SERVICE BULLETIN

STARTING - PNEUMATIC STARTER - INTRODUCTION OF A STARTER FEATURING A SYNCHRONOUS
ENGAGEMENT CLUTCH AND AN OIL PRESSURE FILL FACILITY - CATEGORY CODE 4 -
MOD.ENG-80-0009

V2500-ENG-80-0009

Location of pneumatic starter
Fig.1

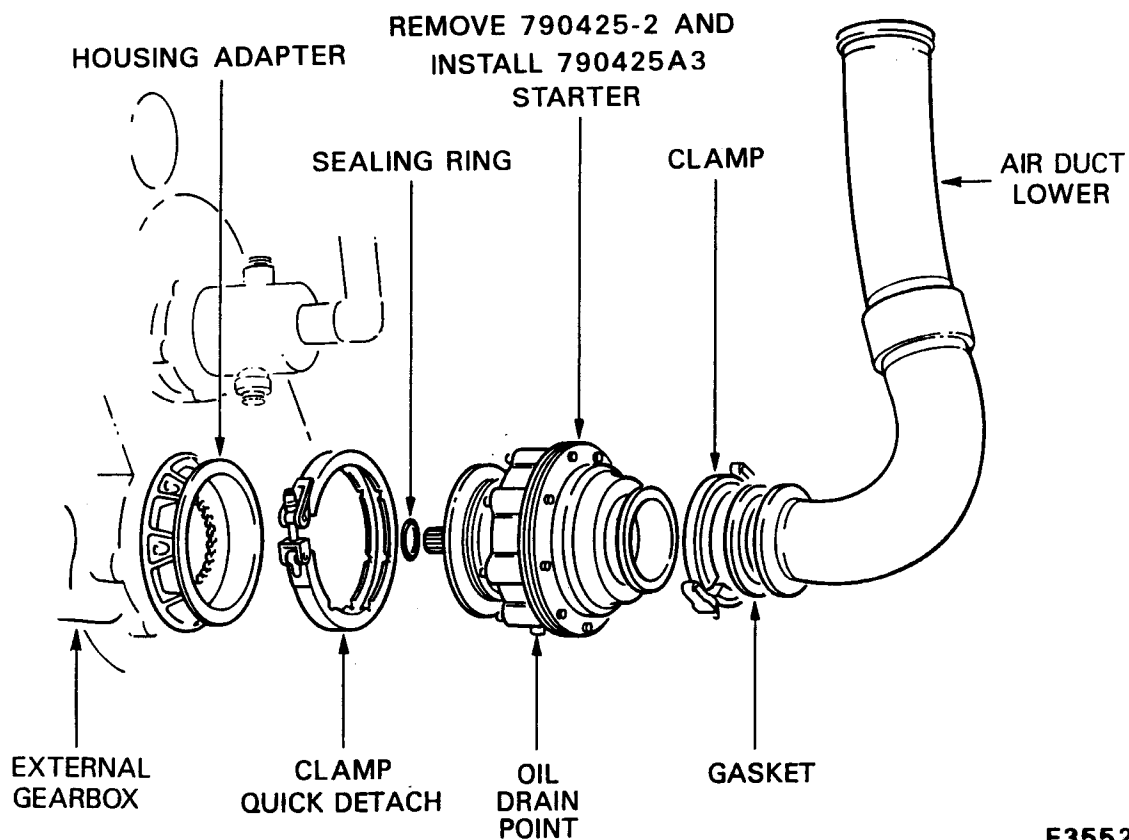
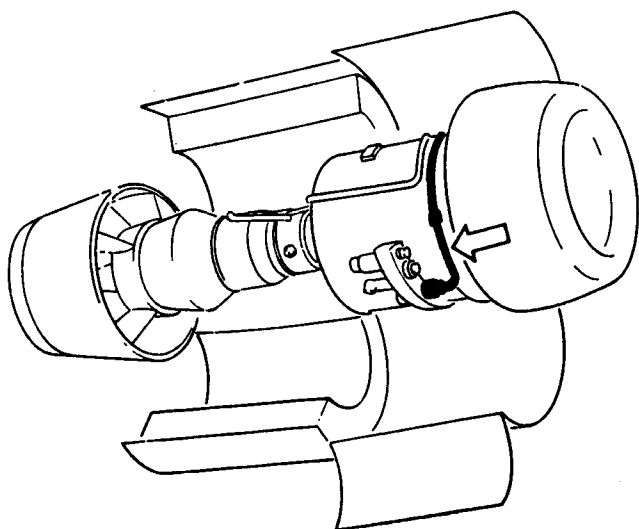
- (1) Remove the 790425-2 starter. Refer to Figure 1.
- (2) Disconnect the air duct from the starter. Disconnect the clamp and swivel the duct and remove the gasket. Retain the gasket.
- (3) Disconnect the quick detach clamp from the adaptor housing. Move the starter forward to disengage the adapter splines and the starter splines. Remove the starter.
- (4) Remove the sealing ring from the starter drive shaft. Discard the sealing ring.
- (5) Install caps to all openings.

- (1) Install the 790425A3 starter. Refer to Figure 1.
- (2) Remove caps from all openings.
- (3) Lubricate the new 69490D216 sealing ring with clean V10-077 engine oil.
- (4) Install the sealing ring on the 790425A3 starter drive shaft.
- (5) Make sure that the oil drain point is at the lowest position. Align the master spline on the starter and the adapter housing. Install the starter in the adapter housing.

- (6) Install the quick detach clamp. Torque the clamp to 60 to 65 inch-pounds (6.78 to 7.34 Nm).
- (7) Install existing gasket on to the air duct. Put the duct in position and install the clamp. Torque the clamp to between 115 to 120 inch-pounds (13.0 to 13.56 Nm).
- (8) Add oil to the starter (See 12-12-80) MD90 Aircraft Maintenance Manual.
